This document reproduces the latest review of the Trumpet Fields planning application (150765) by WSP/PB acting as drainage consultants on behalf of Herefordshire Council. WSP/PB responses to earlier comments on the original WMA Report (February 2015) and subsequent Addendum (June 2015), are highlighted.

SITE:
TYPE: Trumpet Fields adjacent A438, Trumpet, Ledbury HR8 2RA
DESCRIPTION: Planning Permission
 Erection of polytunnels on fields at Trumpet for covered commercial growing
APPLICATION NO: of soft fruit and new pond area
GRID
REFERENCE: 150765
DATE OF THIS OS 366269, 239068
RESPONSE: 02/07/15

Figure 1: Extract from EA's Risk of Flooding from Surface Water Map

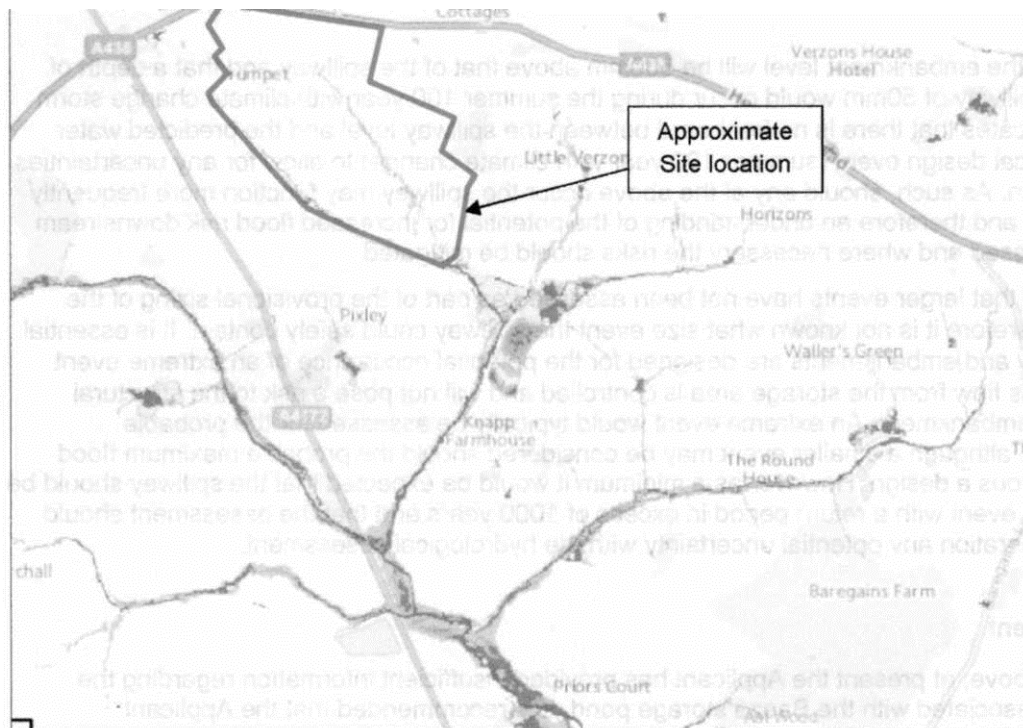
The submitted WMA Addendum includes short statement summarising flood risk assessment at the site. **The provided summary statement is found to be satisfactory.** It is noted that the Addendum states that Figure 5 of the document shows the EA's Risk of Flooding from Surface Water map, but it shows EA's Flood Map for Planning which indicates extent of fluvial flooding. A review of the EA's Risk of Flooding from Surface Water Map (shown below) indicates a potential low risk flow path through the site.

Risk of surface water (as opposed to fluvial) flooding within the site is acknowledged. However, this will be confined to the grass swale to be constructed along the natural W-E depression and will not constitute a risk to life.
